DRAFT TECHNICAL REVIEW REPORT FOR THE LUANG PRABANG HYDROPOWER PROJECT – HYDROLOGY AND HYDRAULICS

THE 9TH MRC REGIONAL STAKEHOLDER FORUM

DAY 1: THE 2ND REGIONAL INFORMATION SHARING ON PRIOR CONSULTATION FOR LUANG PRABANG HYDROPOWER PROJECT

05 FEBRUARY 2020, LUANG PRABANG, LAO PDR

Main review findings (3): tailwater calculations

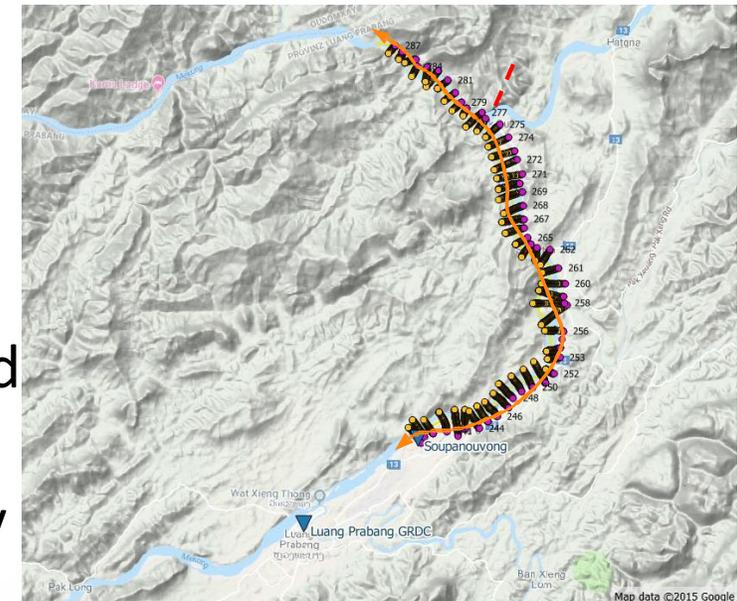
- **Tailwater of LPHPP obtained from numerical 1D model FLORIS**, not accounting for morphological changes and poorly calibrated (no u/s data available for proper calibration and verification of the model and the rating curve, roughness value used)

- The rating curve at Soupanouvong and consequently the resulting curve for PBHPP site, should be corrected for the impacts of operation of the Xayaburi HPP. **The backwater effect of Xayaburi HPP should be included in the curves** (water levels near Luang Prabang do not drop below 275 m). Details on the data for which the rating curve has been established should be shared for review.

- The sensitivity of the tailwater levels to changes in the alluvial deposits and flows from the Nam Ou River into the Mekong should be shown.
- **The developer should share results of model recalibration** based on recent/new measurements of levels and discharges near the dam site and between the Soupanouvong station particularly a calibration for floods.
